RENESAS TECHNICAL UPDATE

Product Category	MPU/MCU		Document No.	TN-SH7-A781C/E	Rev.	3.00
Title	SH7450 Group, SH7451 Group Hardware Manual Errata Rev.C		Information Category	Technical Notification		
Applicable Product	SH7450 Group, SH7451 Group	Lot No.	Reference Document	SH7450 Group, SH7451 Group Hardware Manual Rev.1.00

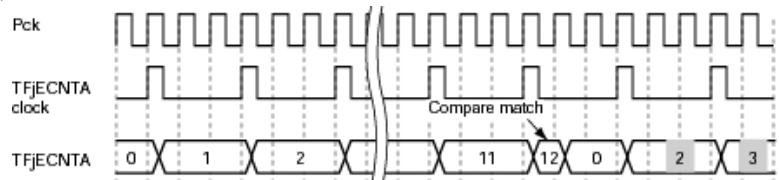
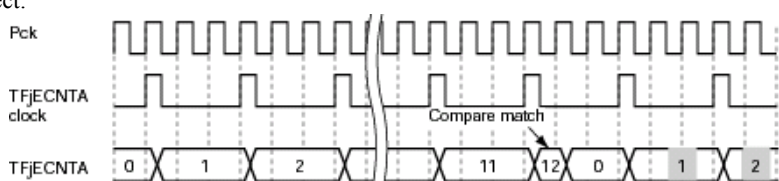
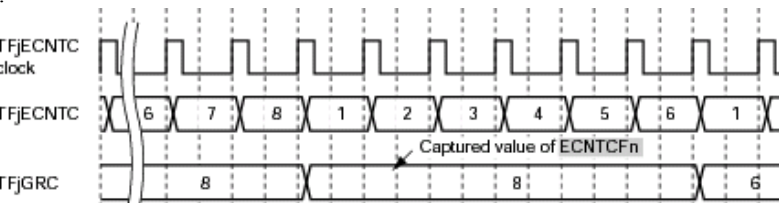
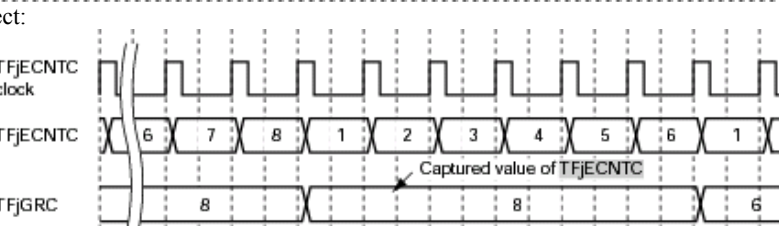
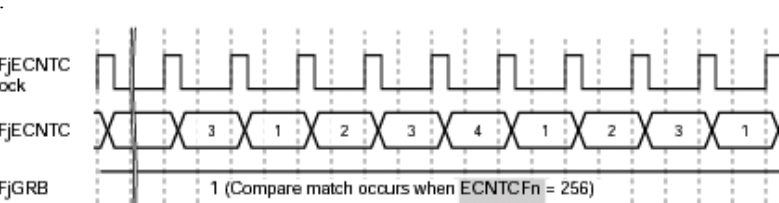
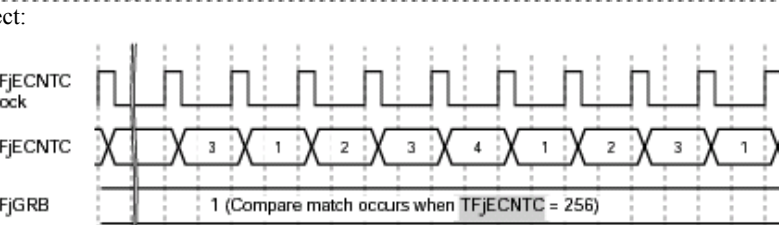
Rev.	Page	Part	Contents
Adds by Rev.C	1-5	Table 1.1 Specifications Overview	<p>Table 1.1 Specifications Overview: Description of SCIF changed. Error: Maximum transfer rate: 3.3 MHz Correct: Maximum transfer rate: <u>3.3 Mbps</u></p> <p>Table 1.1 Specifications Overview: Description of RSPI changed. Error: Maximum transfer rate: 10 MHz Correct: Maximum transfer rate: <u>10 Mbps</u></p>
Adds by Rev.C	1-6	Table 1.1 Specifications Overview	<p>Table 1.1 Specifications Overview: Description of DRO changed. Error: Maximum transfer speed: 10 MHz Correct: Maximum transfer speed: <u>20 Mbps(when 16bits is selected)</u></p>
Adds by Rev.C	1-8	Figure 1.1 Block Diagram	<p>Figure 1.1 Block Diagram: Incorrect description corrected. O in a figure shows the corrected part. Error:</p>  <p>Correct:</p> 
Adds by Rev.C	7-6	Figure 7.4 P4 Area	<p>Figure 7.4 P4 Area: Incorrect description corrected. Error:</p>  <p>Correct:</p>

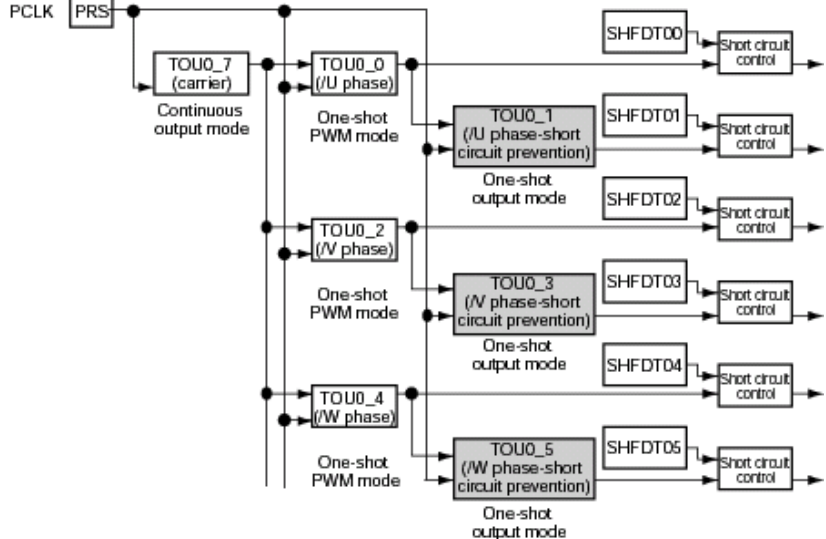
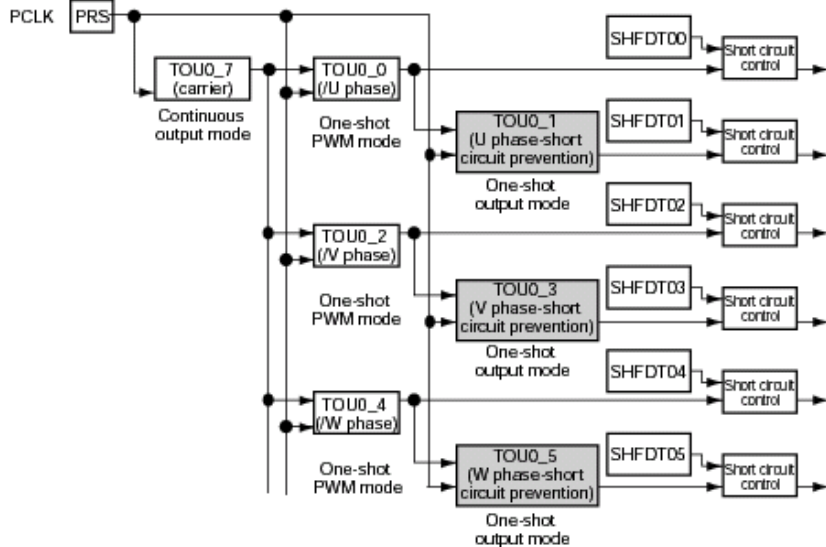
Adds by Rev.C	12-23	Figure 12.8 Command State Transitions in ROM Read Mode and P/E Mode	Figure 12.8 Command State Transitions in ROM Read Mode and P/E Mode: Incorrect description corrected. O in a figure shows the deleted part. Error:  Correct: 
Adds by Rev.C	12-24	12.6.3 FCU Command Usage	Incorrect description corrected (the 11th line). Error: If the FRDY bit is held in the "0" state for a period longer than the program/erase time <u>or the suspend delay time</u> (see section 38, Electrical Characteristics), ----- Correct: If the FRDY bit is held in the "0" state for a period longer than the program/erase time (see section 38, Electrical Characteristics),
Adds by Rev.C	15-3	15.1.1 Interrupt Request Sources in INTC	Incorrect description corrected (the 2nd line). Error: The INTC manages non-maskable interrupt (NMI interrupt) and general interrupt (<u>IRQ interrupt</u>) and on-chip peripheral module interrupt requests in <u>exceptional handling</u> . ----- Correct: The INTC manages non-maskable interrupt (NMI interrupt) and general interrupt (<u>IRQ interrupt and on-chip peripheral module interrupt requests in exceptional handling</u>).

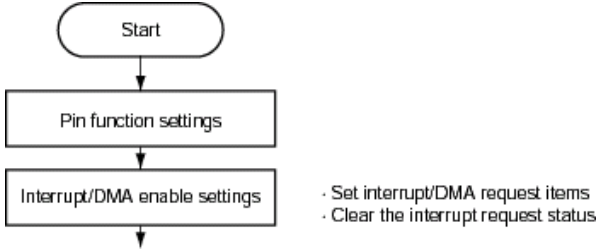
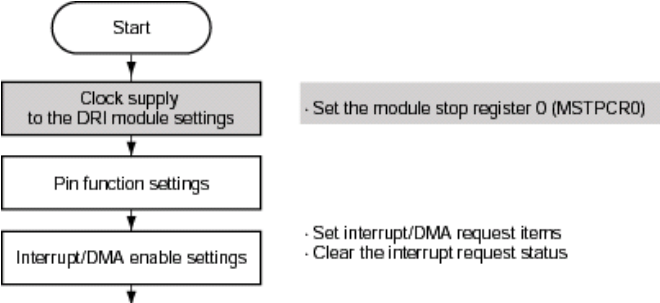
Adds by Rev.C	21-129	Figure 21.29 PWM Circuit Diagram	<p>Figure 21.29 PWM Circuit Diagram: Description of reload register corrected.</p> <p>Error:</p>  <p>Correct:</p> 
Adds by Rev.C	21-142	Figure 21.39 Operation Example of One-Shot PWM Output Mode (Reload 0 Register: H'FFFF)	<p>Figure 21.39 Operation Example of One-Shot PWM Output Mode (Reload 0 Register: H'FFFF): Notes corrected.</p> <p>Error: *1 The value of the reload 1 register is reloaded in the counter because the reload 1 register is set to H'FFFF.</p> <p>Correct: *1 The value of the reload 1 register is reloaded in the counter because the reload 0 register is set to H'FFFF.</p>
